**September 4, 2013, Letter from Tetra  
Tech to MassDEP  
(the “September 4, 2013 Supplement”)**

**Re: Major Comprehensive Plan Application  
Salem Harbor Redevelopment (SHR) Project (Transmittal Number X254064)  
Additional Information**

**(7) GE load range for emissions guarantees**

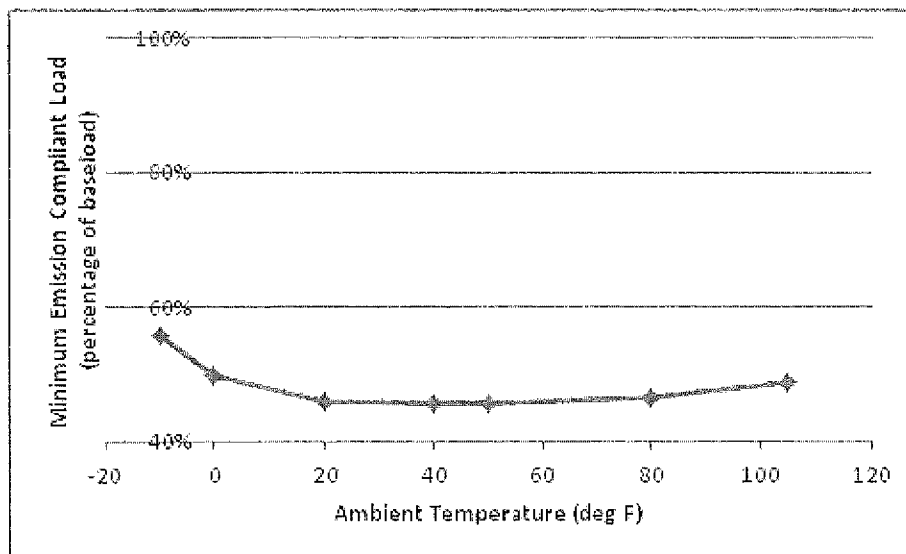
GE has guaranteed compliance with emission limits over a CT load range from “MECL” to Peak firing conditions. MECL as a function of ambient temperature is shown below.
